# Technical Service Bulletin

Mazda North American Operations  
Irvine, CA 92618-2922

<b>Subject:</b>  <b>HARD SHIFTING/SHIFT LEVER VIBRATION</b>	<b>Bulletin No.:</b> 05-005/19
	<b>Last Issued:</b> 06/06/2019

#### Location of Transmission Related Parts

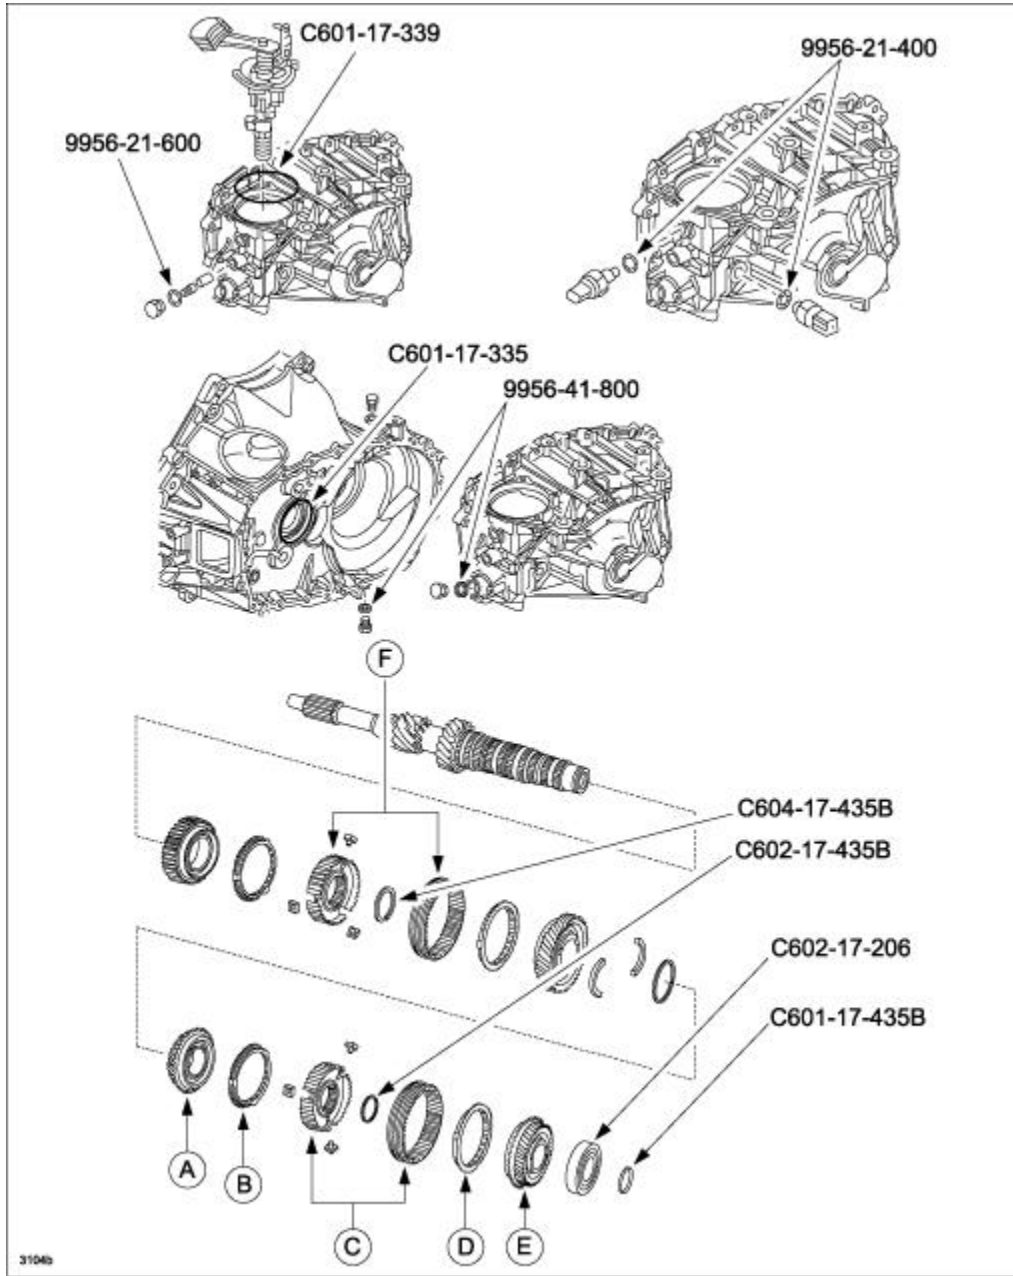
A: 3rd Gear

B: 3rd Synchronizer Ring

C: 3/4 Clutch Hub Assembly

D: 4th Synchronizer Ring

E: 4th Gear

F: 5/6 Clutch Hub Assembly

Parts Number	Description	Qty.	Notes
C602-17-240B	3-4 Clutch Hub Assembly	1	
C602-17-26YB	Synchronizer Ring	2	
C602-17-620C	5-6 Clutch Hub Assembly	1	Combination 1: Only when C602-17-620C is available (Use current Synchronizer Ring C604-17-26YB)

-	Synchronizer Ring	0	
C602-17-620D	5-6 Clutch Hub Assembly	1	Combination 2: Only when C602-17-620D is available
C614-17-26YA	Synchronizer Ring	2	
C601-17-230D	3rd Gear	1	Part numbers of gears are different depending on the variation of the gear ratio. Check EPC for the correct part number for the repair VIN.
C610-17-230C			
C601-17-210E	Gear, Main Drive (See note below)	1	
C603-17-210B			
C613-17-210B			
F401-17-313	Reamer Bolt	6	
C601-17-435B	Retaining Ring	1	
C604-17-435B	Retaining Ring	1	
D602-17-435B	Retaining Ring	1	
C602-17-206	Ball Bearing	1	
C601-17-339	"O" Ring	1	
C601-17-335	Oil Seal	1	
9956-21-400	Washer	2	
9956-21-600	Washer	1	
9956-41-800	Washer	2	
0000-77-5W80-QT	Manual Transaxle Oil	3	Specification: 2.6 - 2.7 US qt
